BID MEMO 01

<u>Saints - Cafeteria & Viewing Area</u>

REVISION #01

New Orleans Saints Viewing Area and Cafeteria Expansion 5800 Airline Drive Metairie, Louisiana 70003

2 SECOND FLOOR VIEWING AREA NANAWALL SL45
A6.31 1/4" = 1'-0"

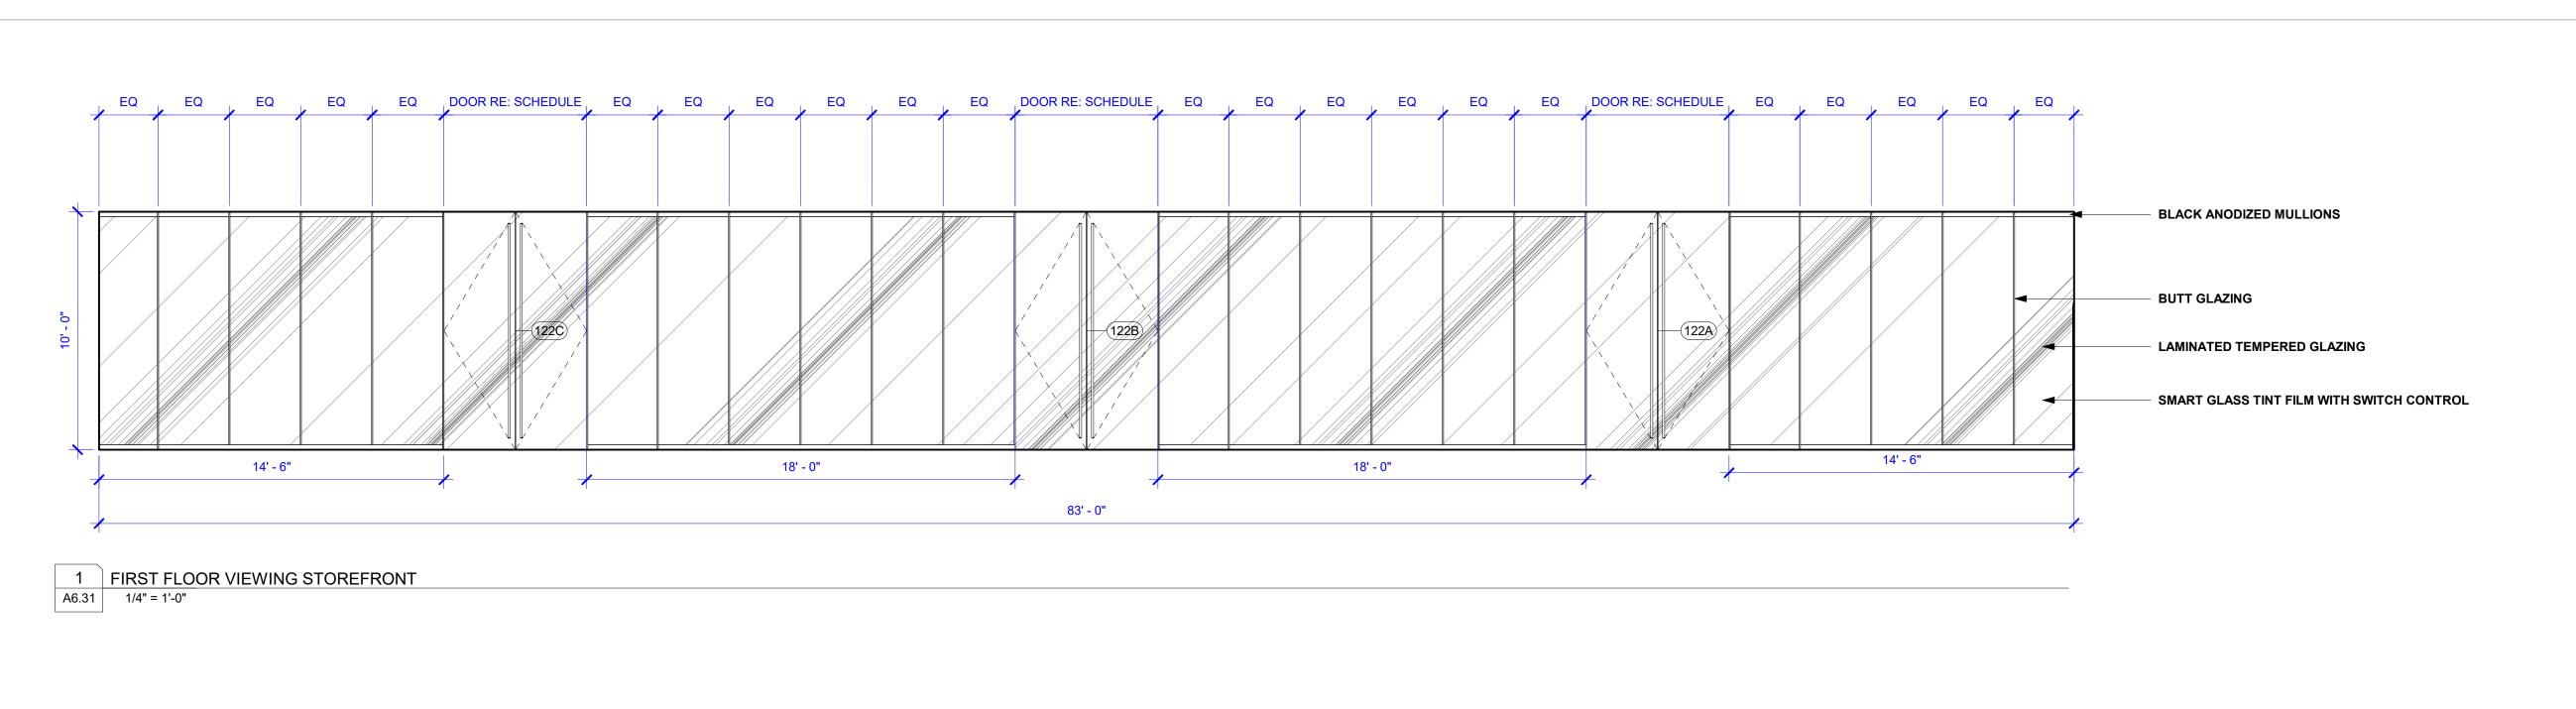
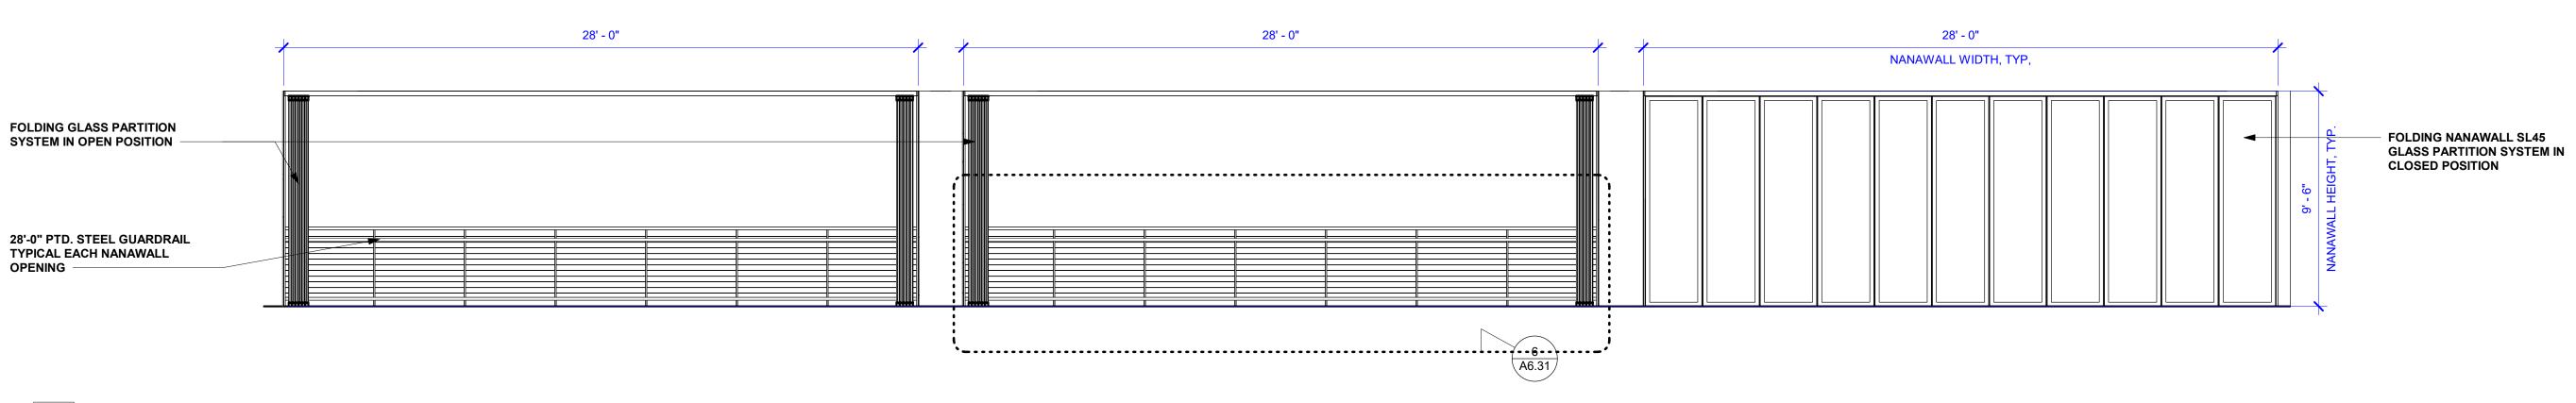
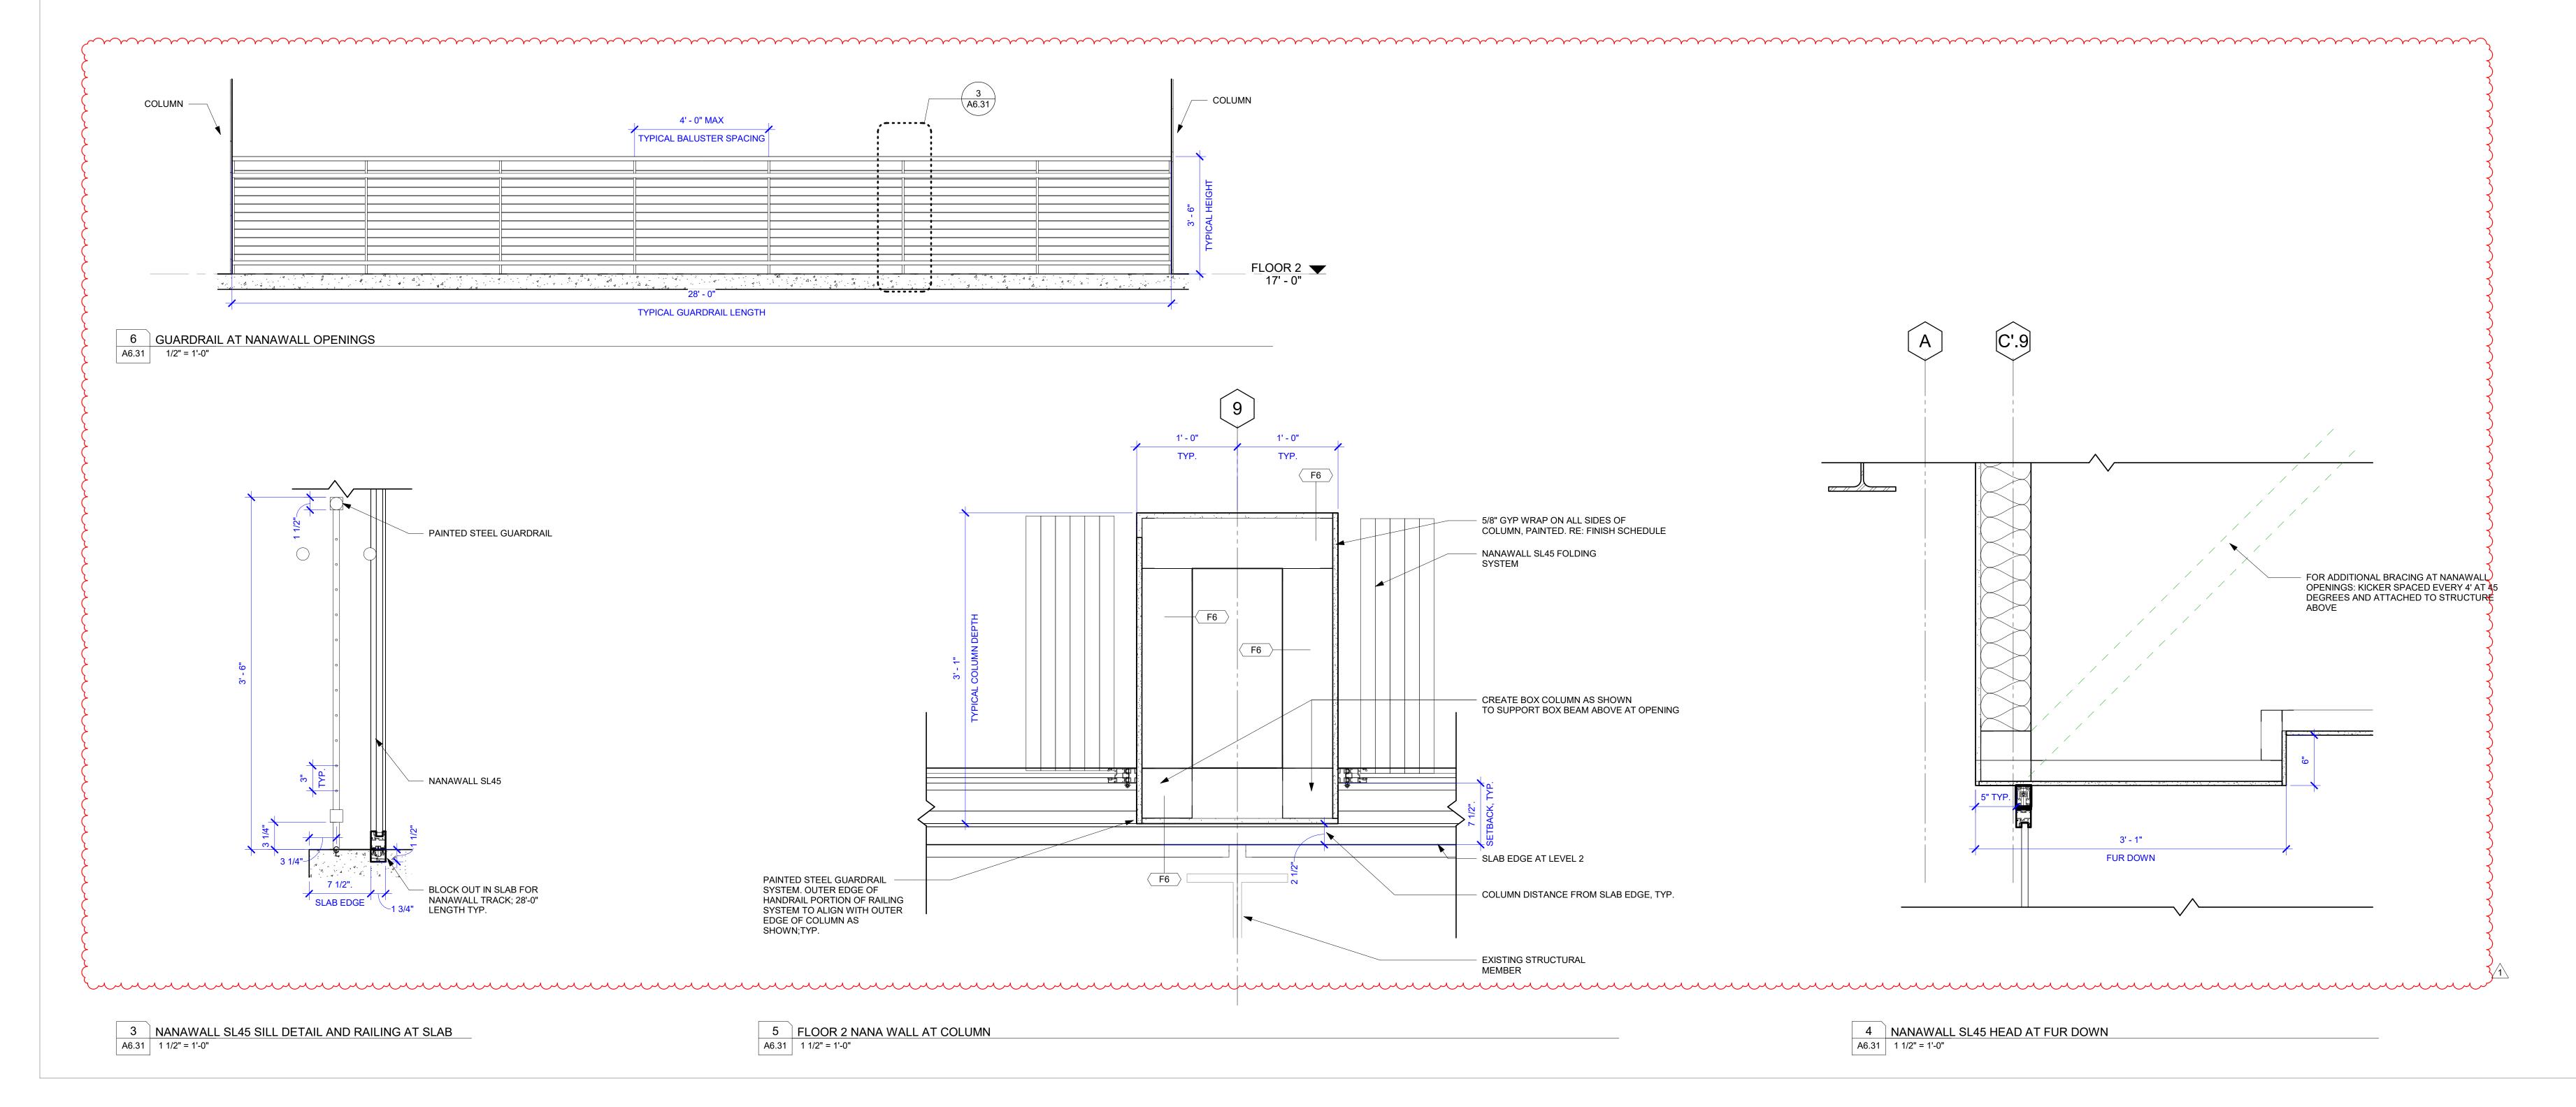
- Guardrail detail revised at view area 200 & valley gutter detail showing steel angle support A5.11
- Revised viewing area guard rail details A6.31
- Plastic laminate color identified on room finish legend. Wall tiles and floor tiles colors were identified for restrooms - A6.50

INTERIOR ELEVATIONS - DINING HALL

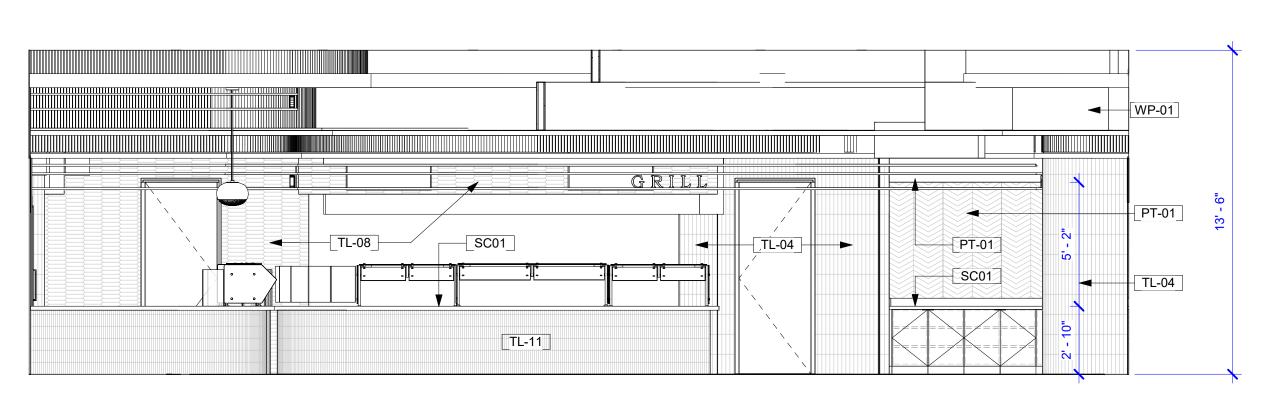
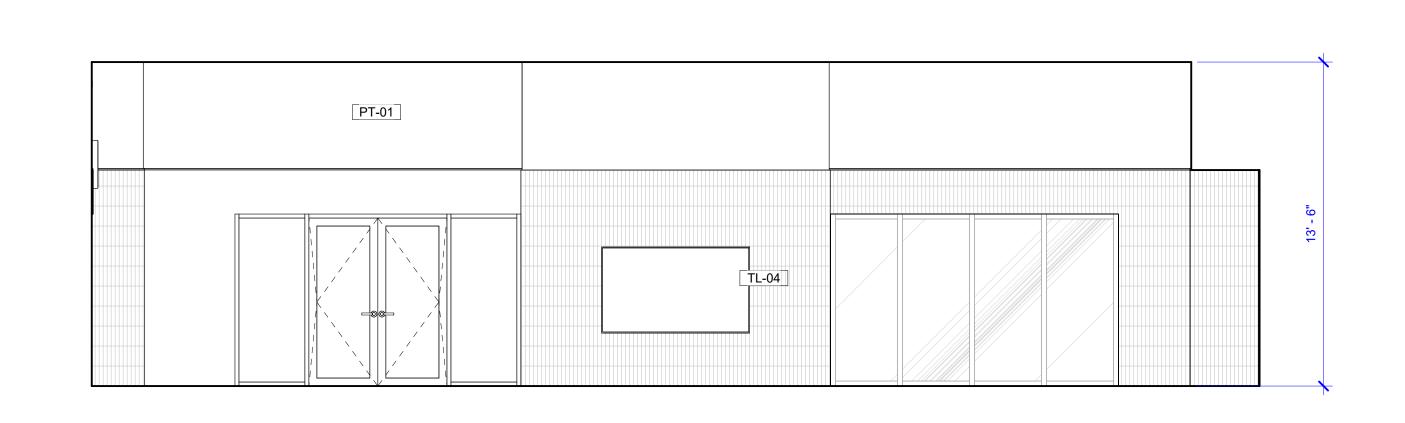
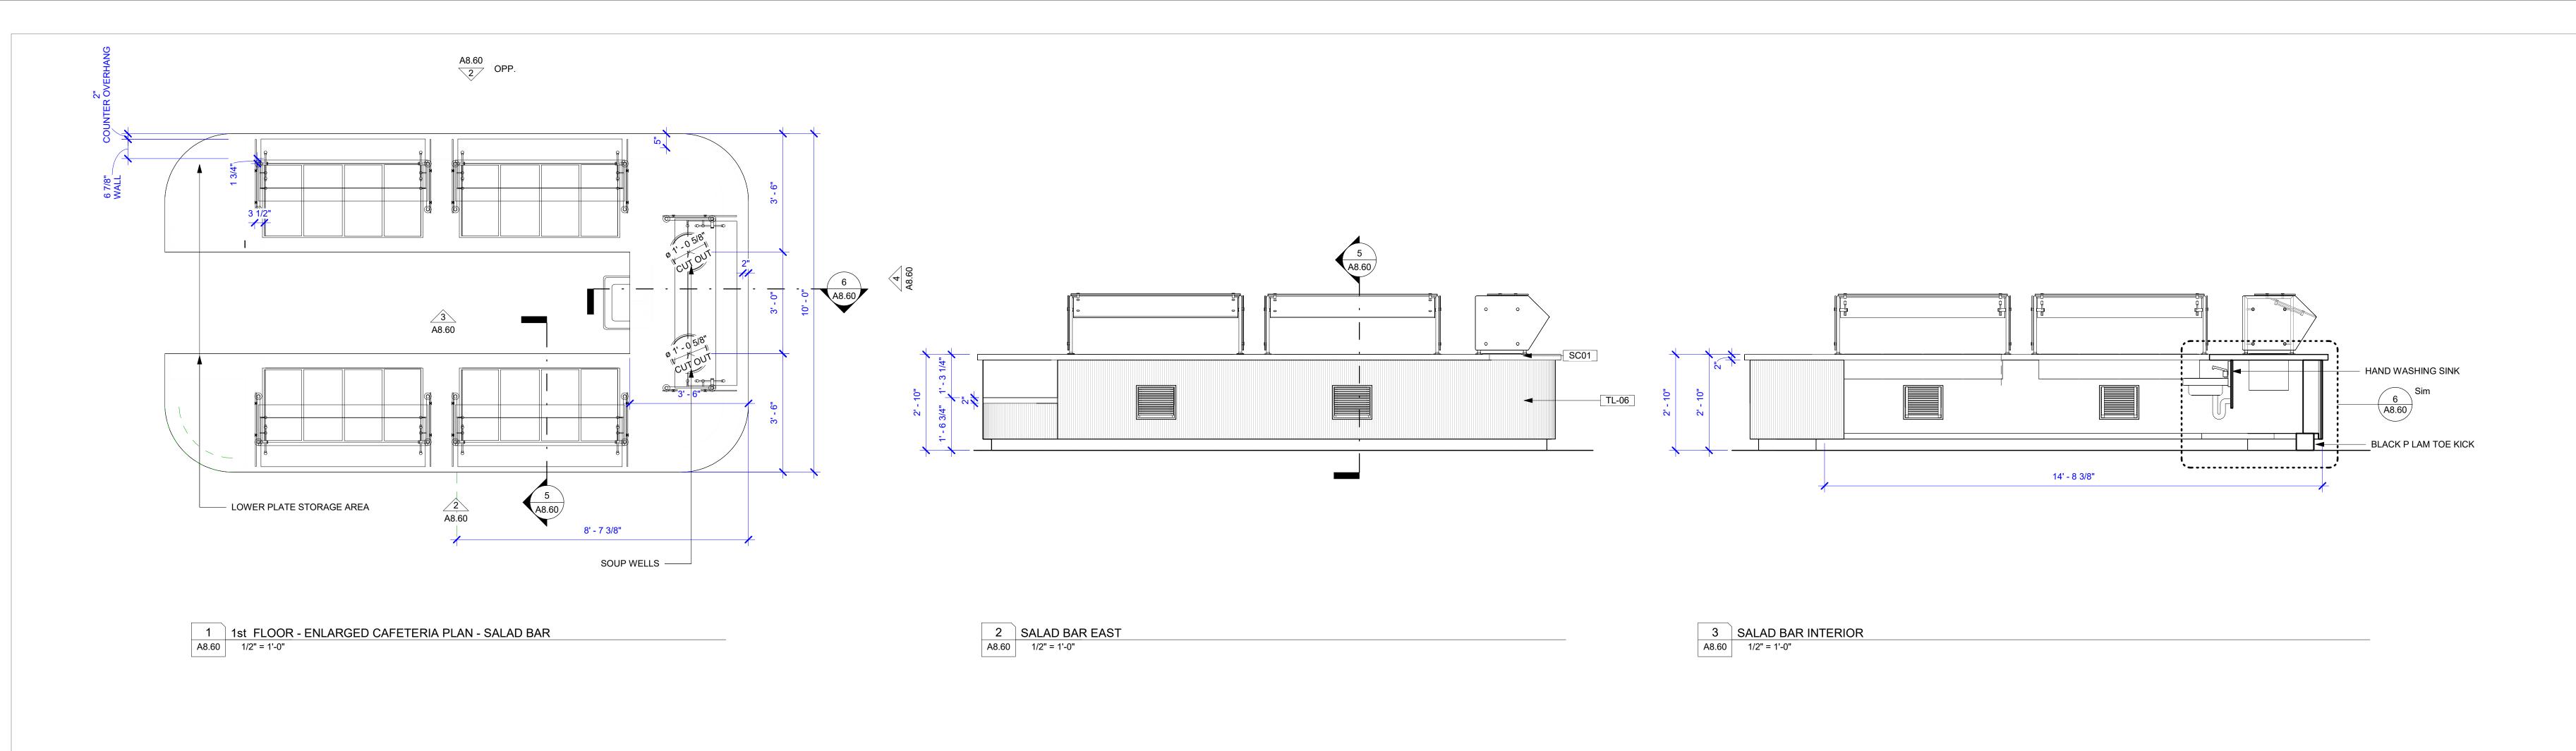
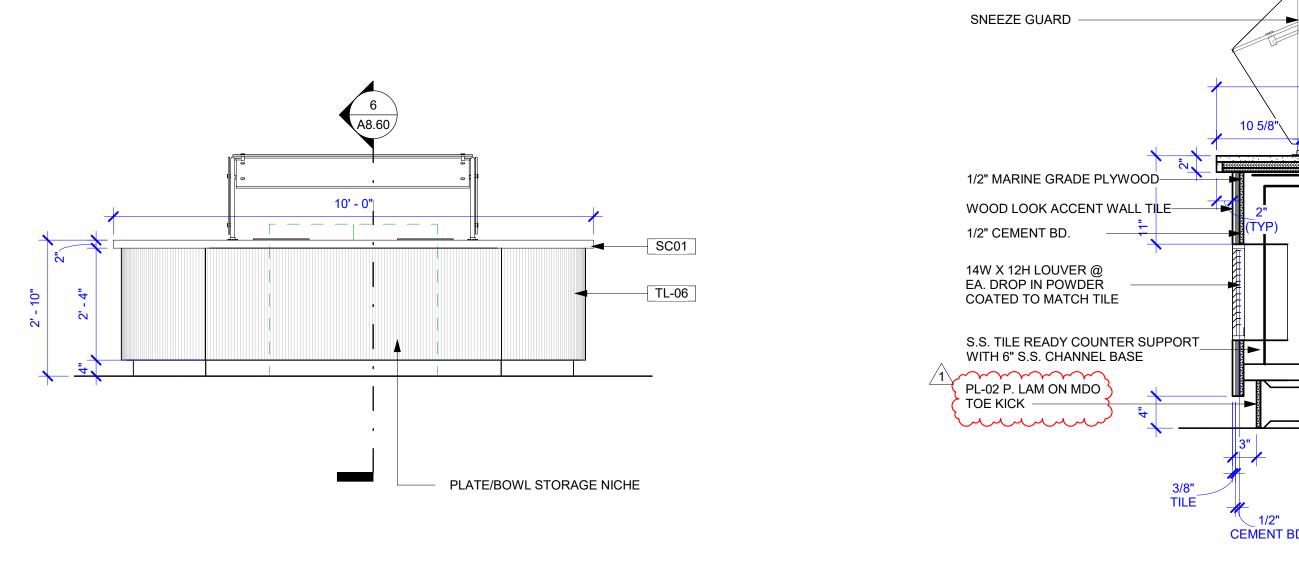
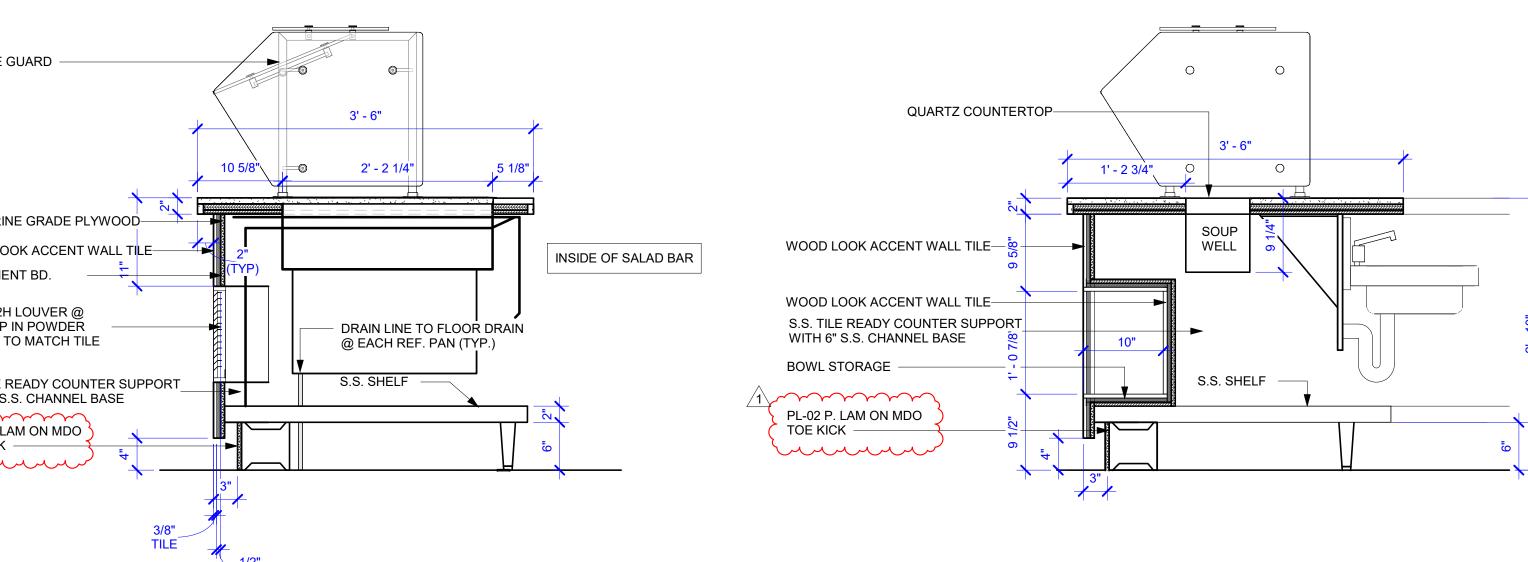
- 2 keys notes added for new schulter strips A8.10
- Plastic laminate adjustment at toe kicks- A8.60, A8.61, A8.63
- Updated edge condition at countertops (2" typ.) 7/A8.61
